# Certificate of Appropriateness

<b>Property</b>	<b>407 N Hawley Road.</b>	<b>Bungalow Firehouses</b>
<b>Description of work</b>	Replace main garage doors, replace one side door, patch masonry, per attached designs.	
<b>Date issued</b>	4/17/2014	PTS ID 114682 COA, two doors

**NEW EAST ELEVATION**

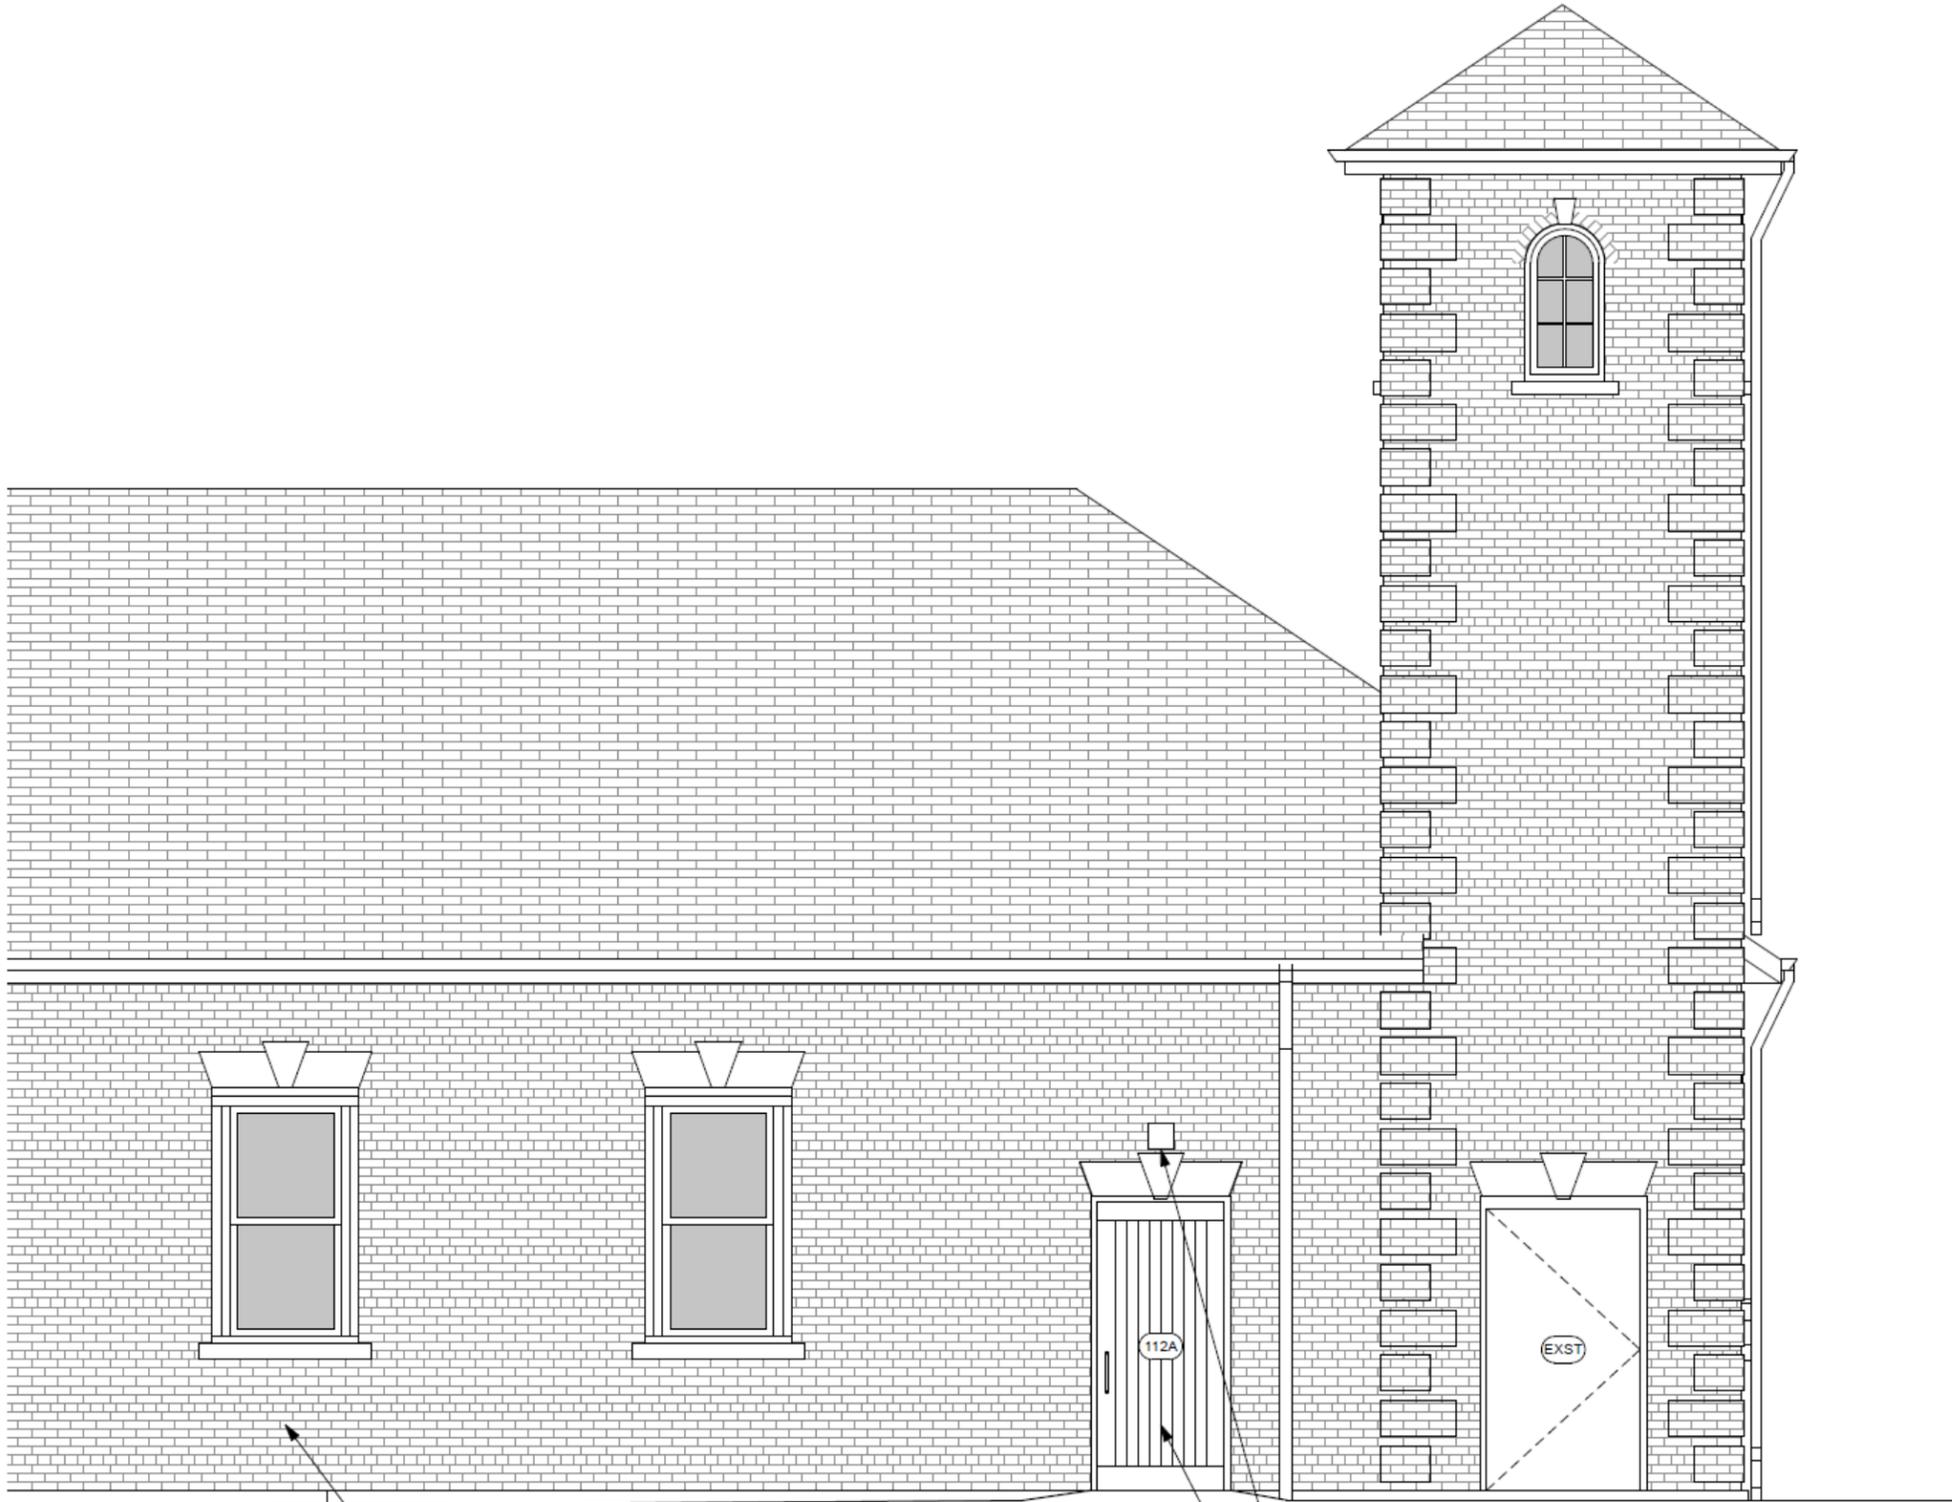
EXISTING DOOR LEAF TO BE MODIFIED FOR RECONFIGURED SWING.

CARRIAGE DOOR HINGES AND PULLS  
COLOR: BLACK  
COORDINATE PROFILES WITH THE ARCHITECT.  
SOLID WOOD CARRIAGE DOOR AND FRAME  
ASSEMBLY. WOOD SPECIES: DOUG FIR  
COORDINATE STAIN COLOR WITH THE ARCHITECT.

WOOD FRAME WINDOW ASSEMBLY WITH 1/4" SANDBLASTED, SAFETY GLASS - TYPICAL.
